**SAN ANTONIO WATER SYSTEM
HIGHLAND ESTATES, UNIT 1 P.U.D. MONTANA PASS FLOATING GROUND
STORAGE TANK PROJECT**

**SAWS JOB NUMBER 15-1177
SOLICITATION NO. CO-00092**

**ADDENDUM NO. 5
October 13, 2016**

DEVELOPER: SWS	
CONT.	BUDGET PROJ.
SUBMITTED _____	
APPROVED _____	
MAP No.	SHEET
SECT. No.	C-5.1R1
DR.	CK.
JOB No. 15-1177

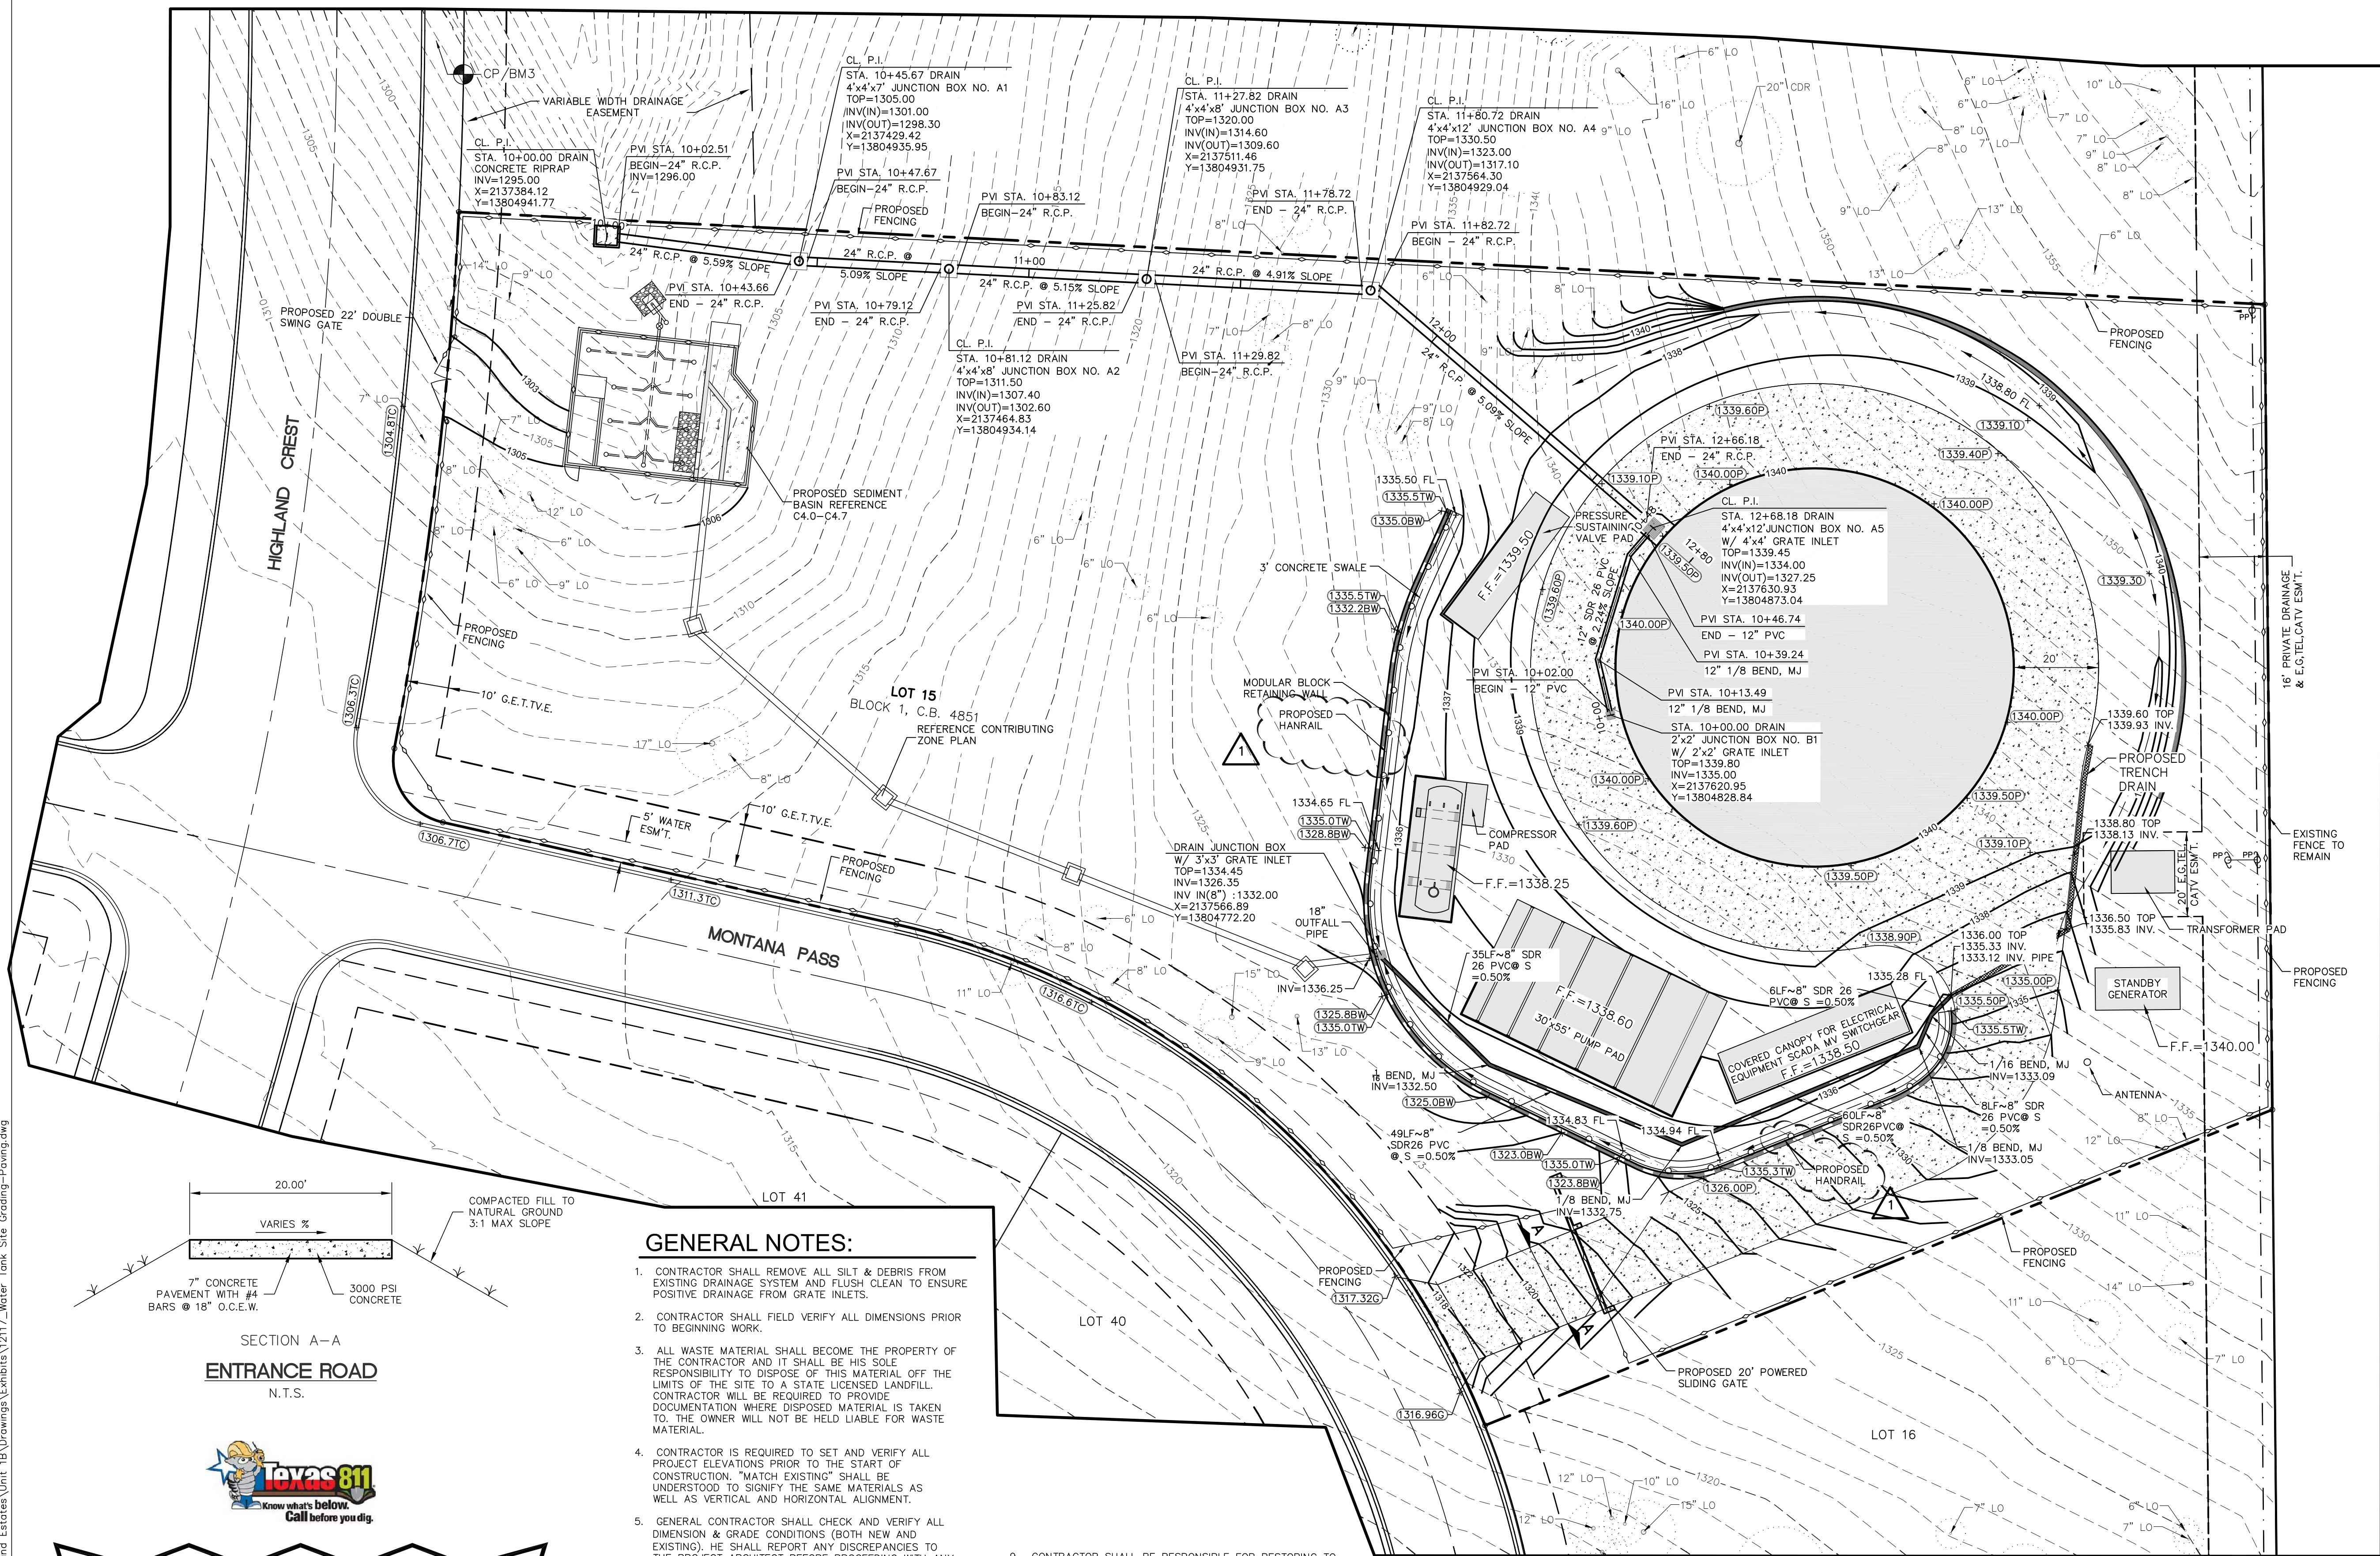
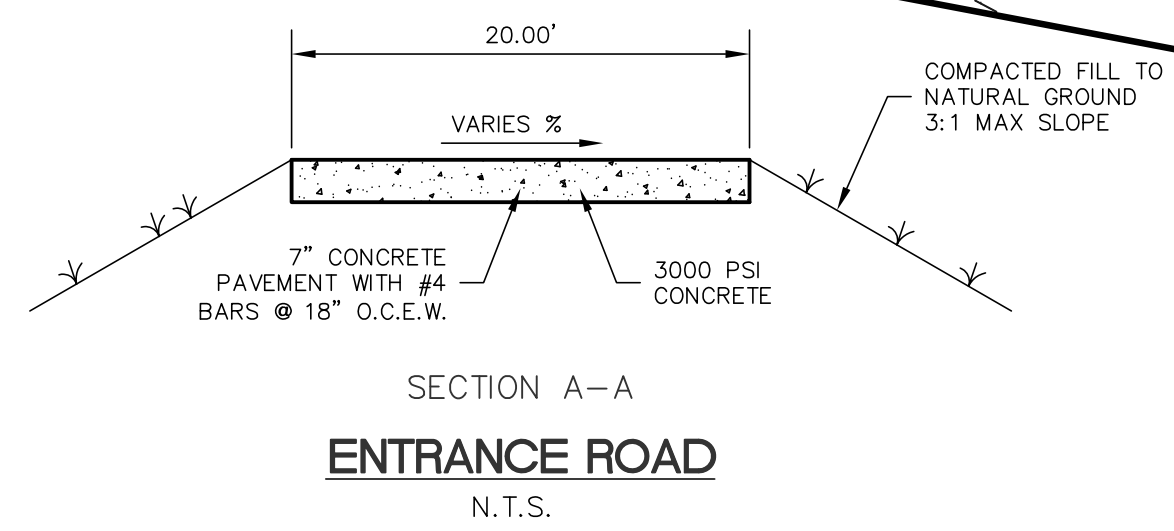
13. On sheet C-4.0 both site gates are shown to be 22' double swing gates, but on sheet C-5.1 the gate coming off of Montana Pass is shown to be a 20' powered sliding gate. Which gate is correct?
Gates shall be as shown on Sheet C5.1 with a double swing gate off Highland Crest and a 20' powered sliding gate off Montana Pass. Reference C4.0R1 and C5.1R1.

14. Is there fence required on the East side of the site running parallel to the existing fence? Sheet C-4.0 appears to show us tying into the existing fence running North and South, but sheet C-5.1 shows proposed fence running North and South alongside the existing fence.
Fence shall follow layout on sheet C5.1. Reference C4.0R1 and C5.1R1.

SHEET C-5.4R1

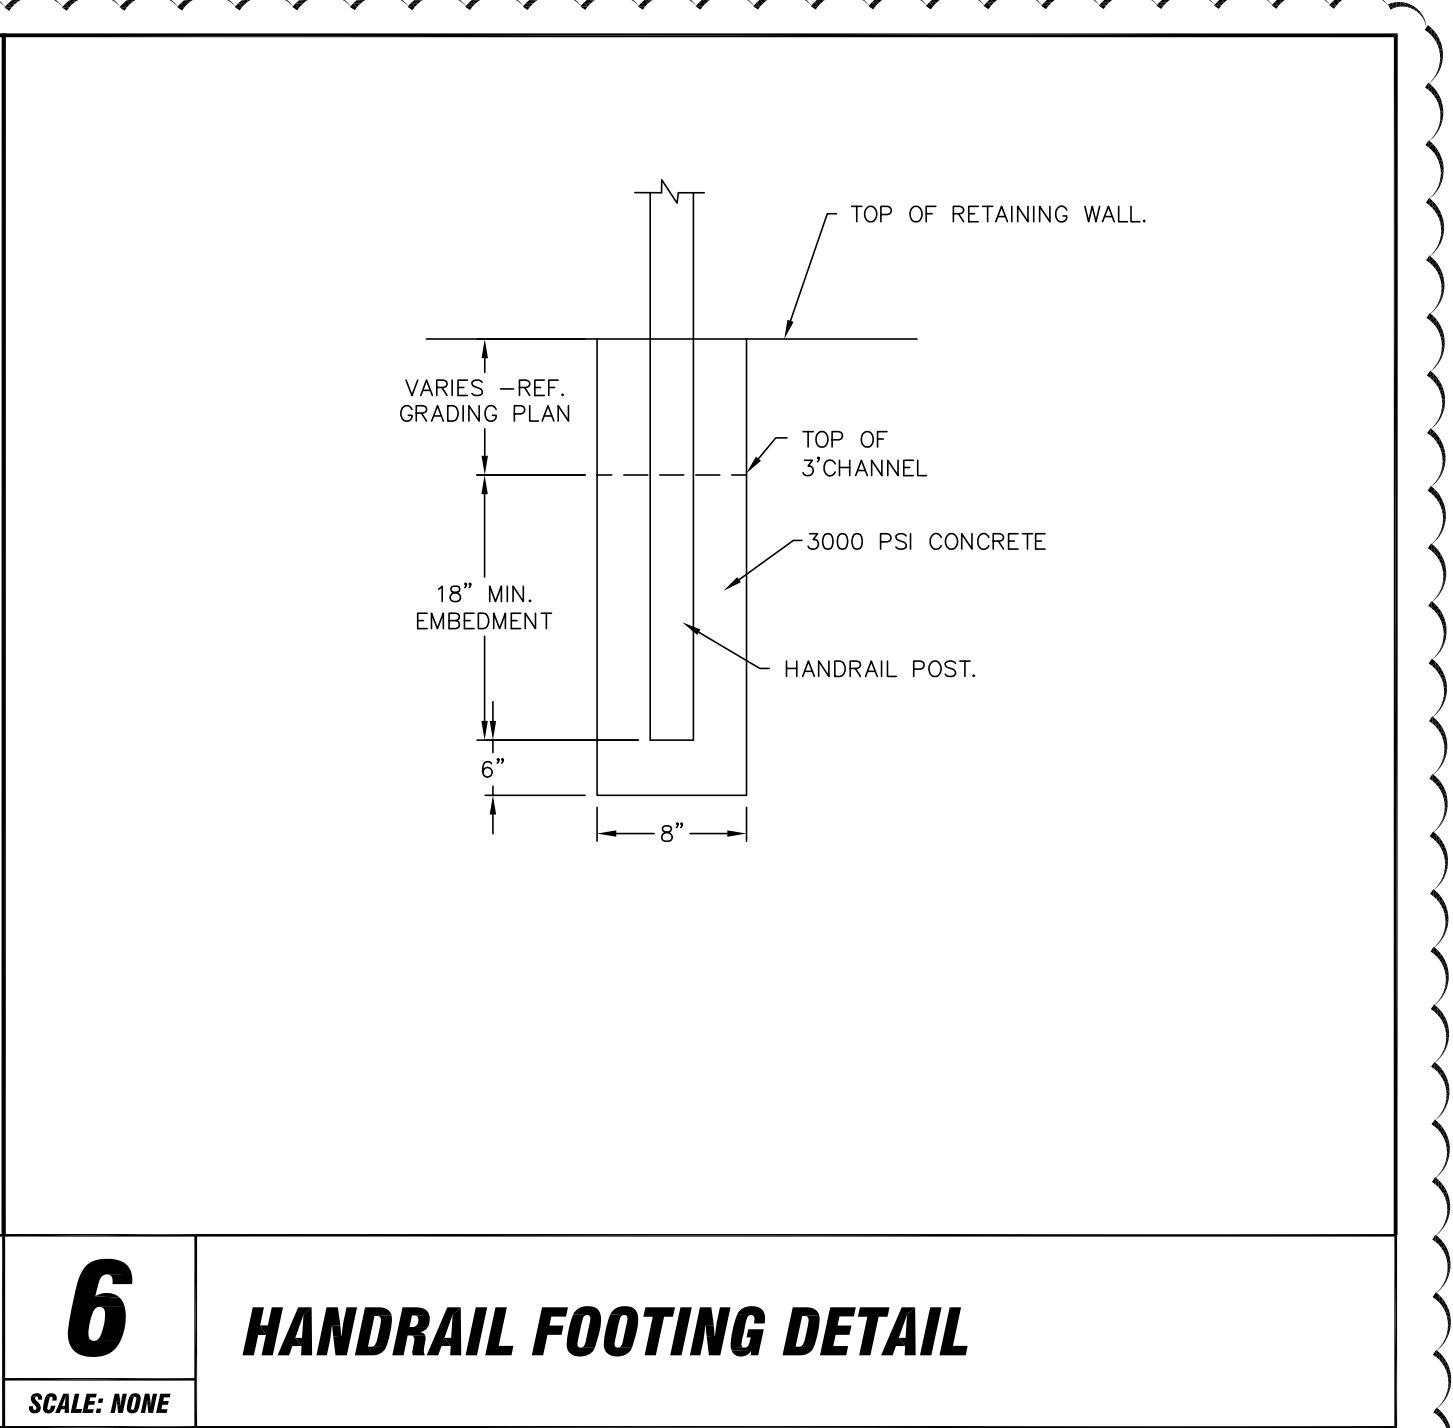
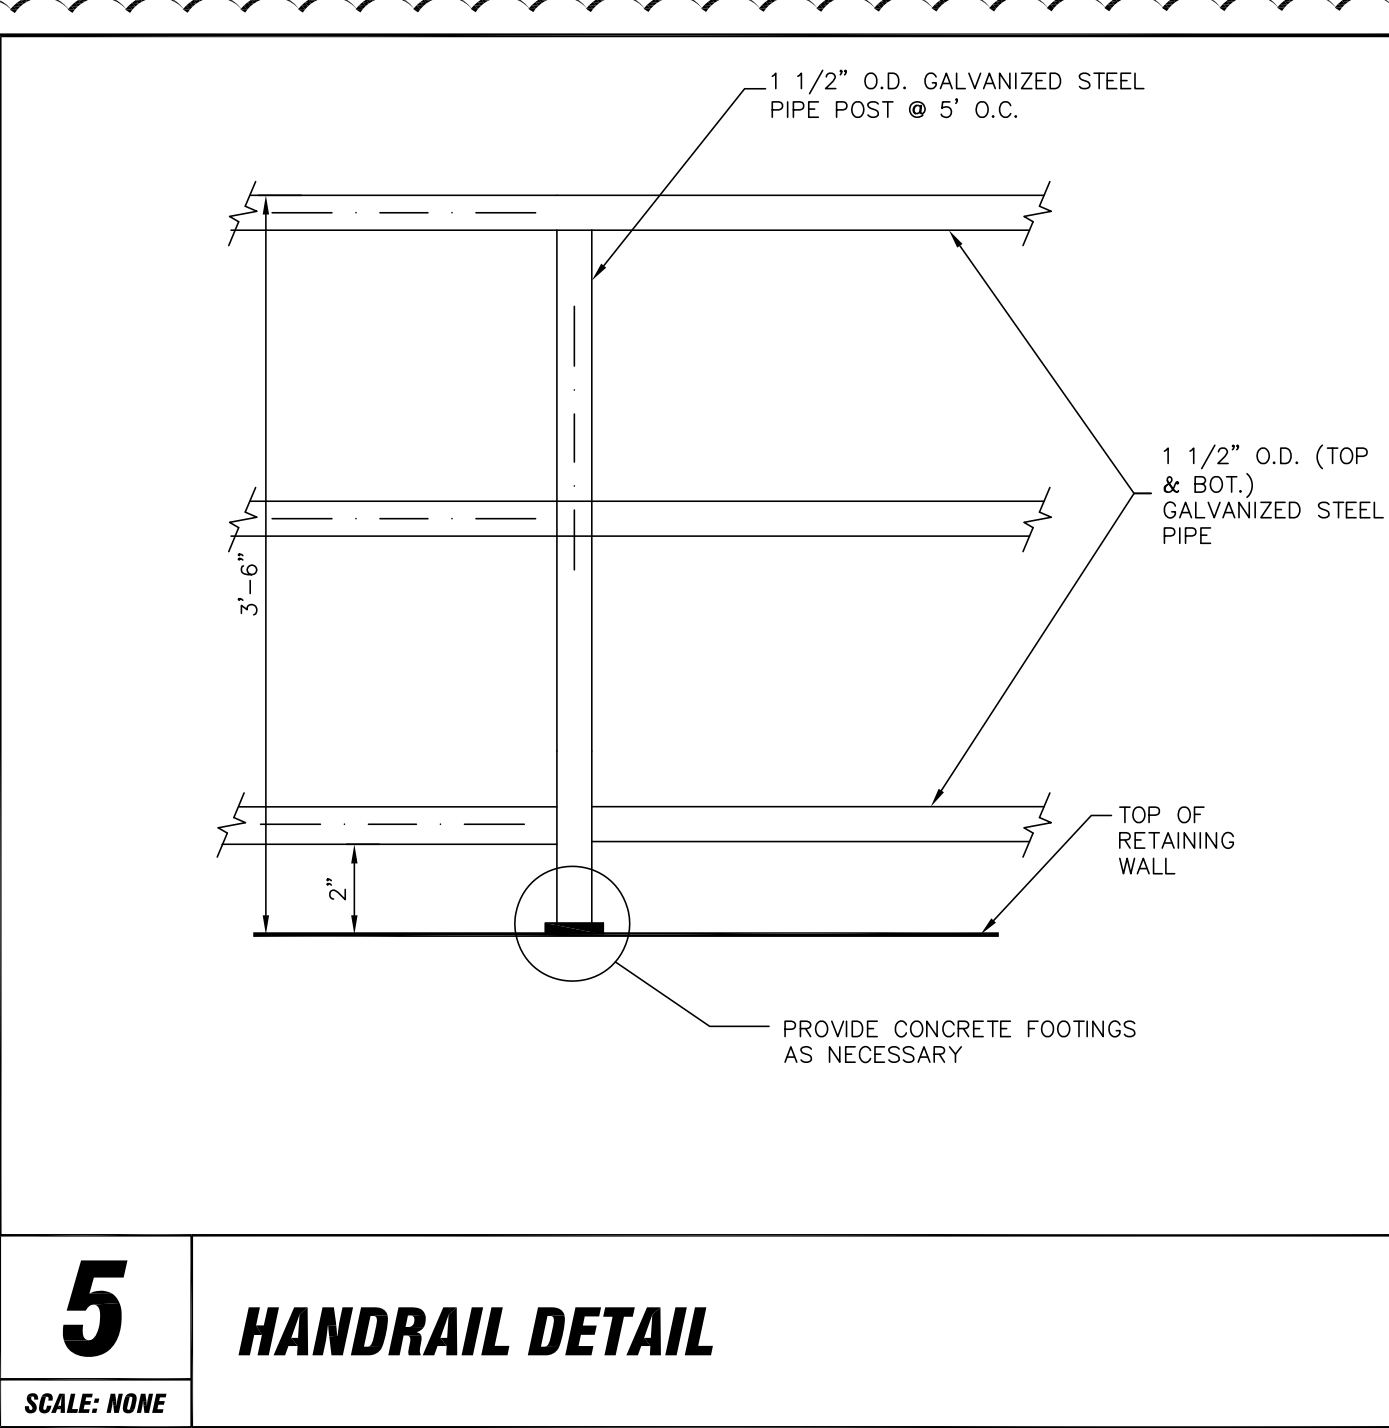
15. Is there a detail and spec for the proposed trench drain running across and alongside the tank access road?
Reference sheet C5.4 for detail of trench drain. Installation to be as per manufacturer recommendations.
